Planning Commission Staff Report

Case File: Site Plan Review (SPR) 23-05 – Historic Review

Request: Consideration of a Site Plan Review application within the Single-family Residential/ Historic District Zone to: modify an existing single-family home to (1) Replace wood windows with vinyl; (2) Paint the exterior façade, trim, gutters, and door; (3) Replace lighting fixtures visible from the public right-of-way; and (4) Find the project subject to the California Environmental Quality Act (CEQA) as the project does not comply with the Secretary of Interior Standards and Guidelines.

Figure 3. Existing Windows

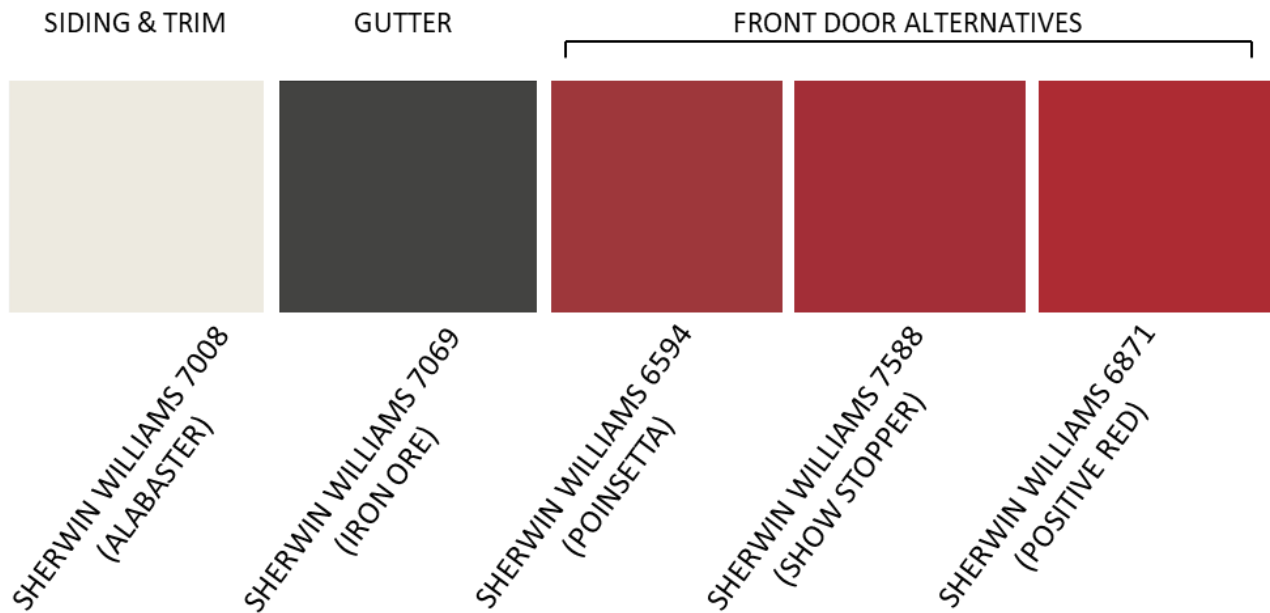
The proposed project includes the removal and replacement of the existing wood windows with new vinyl windows. Figure 3 shows the existing windows, with eleven (11) locations with single-hung wood windows and one (1) fixed/picture wood window. The proposed windows are shown in Figure 4 below, along with the locations on a scaled drawing. The proposed windows are Simonton Madeira single-hung and picture windows.

It is Staff's opinion that replacement of the existing windows with vinyl is inconsistent with actions recommended by the SOI Standards and Guidelines and reduces the historic integrity of the building, becoming less historic. The SOI Standards and Guidelines recommend that historic windows should be repaired when possible and, when too deteriorated to repair, replaced with windows meeting Standard 6, where the replacement windows shall match the old in design, color, texture, and, where possible, materials (wood for wood).

The existing windows are single pane and wood framed. Per the property owner, a majority of the windows do not seal properly. Additionally, some of the windows have either broken or cracked glass and others are crooked.

The proposed project would not repair the existing windows or replace the windows with matching design, color, texture and materials.
